SUN MOUNTAIN TOWNHOMES ZONE CHANGE AND DEVELOPMENT PLAN

PROJECT STATEMENT 2ND SUBMITTAL

Comments on Project Statement 2nd Submittal ---Kelly Hiller ----September 21, 2024

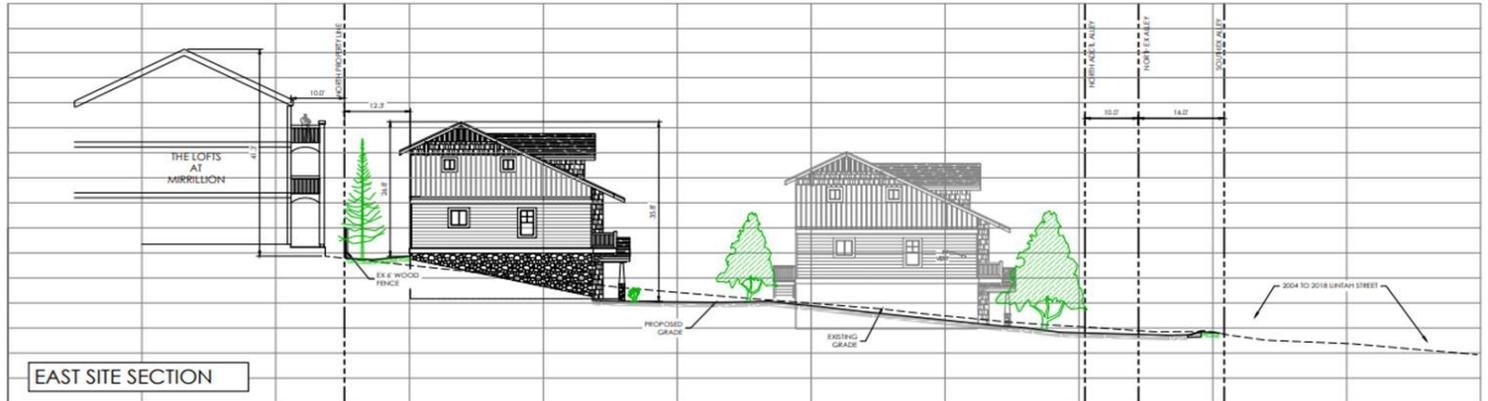
Additionally, due to the grade of the site, these buildings will sit at a much lower elevation than the existing townhomes to the North making them feel less prominent. The single, 2-unit building is placed on the southeast portion of the project site with a maximum height of 32' which is more compatible with the adjacent 1 and 2-family uses next door and along W Uintah St.

The below drawing DOES NOT accurately represent the building on the left (Mirrillion)

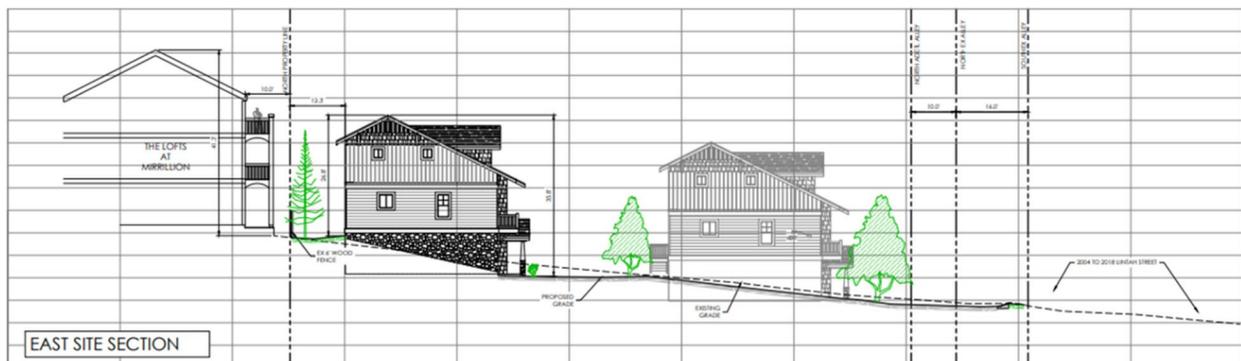
The alley will provide necessary access to the lots in this development which was removed when Henderson Street was vacated. **The applicant's lots never had access from Henderson Street. Henderson Street never existed nor provided access to anyone.**

While alleys are not typically intended for primary access **(they are NEVER intended for or permitted to be primary access for single-family attached housing)**, there are provisions in the code that allow for it to be primary access when adjacent to arterial roads such as Uintah Street. **(This is not permitted by City Code as the alley does not touch Uintah Street and the proposed project is single-family attached housing, not multi-family)**

BUILDING ELEVATIONS FOR LOTS 1-4 & 21-24

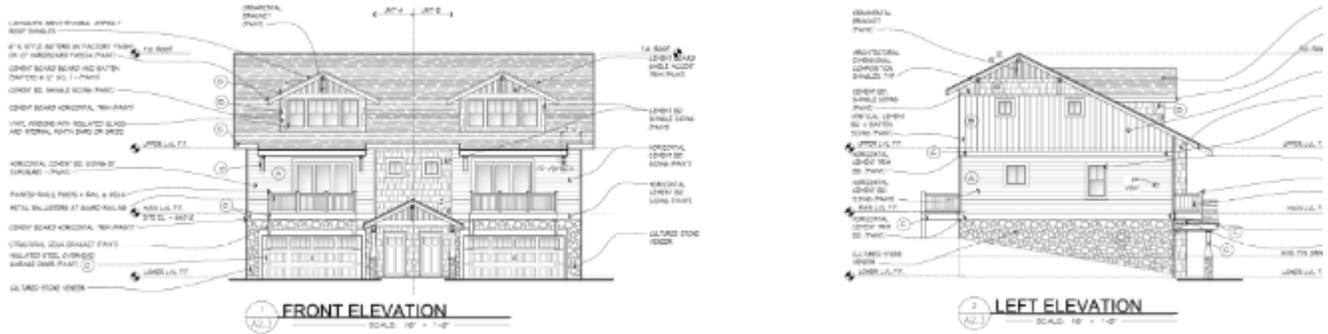
In the Project Statement, the applicant says "*The buildings are proposed to be 3 stories and 32' in height.*" And "*The maximum height of the structures is 32'.*" And "*the proposed townhome buildings will have a maximum height of 32'.*" But, the drawings on sheet 8 of the development plan show that 8 of the 26 units are over 34 feet tall. And the cover sheet of the development plan shows the proposed height is 34.3'.

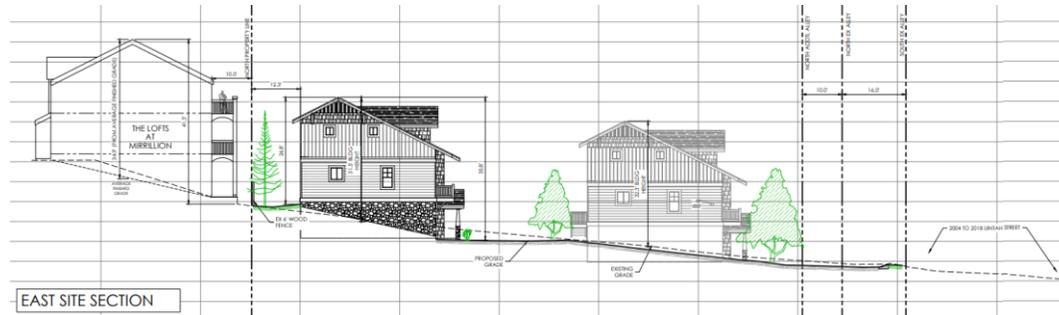
The city has accepted that the existing alley will remain an alley. Improvements to the alley will be required by the developer which will include paving the alley to meet city engineering standards which will improve drainage conditions and vehicular access. Double frontage lots will not be created with this project because the alley will not become a street. The City's subdivision code states that the intent is to promote design flexibility, ensures safe and effective emergency response, and provides for adequate vehicular access to all adjacent properties. City Traffic Engineering, Engineering Development Review, Fire, and Planning have all reviewed the proposed access for compliance with the respective codes and policies and provided no objections to this design. Further, when a property cannot meet every standard of access, City engineering staff may designate access points based on traffic safety, operational needs, economic development, and conformance to as many of these standards as possible. Access from an alley is not strictly prohibited by any City codes or policies.
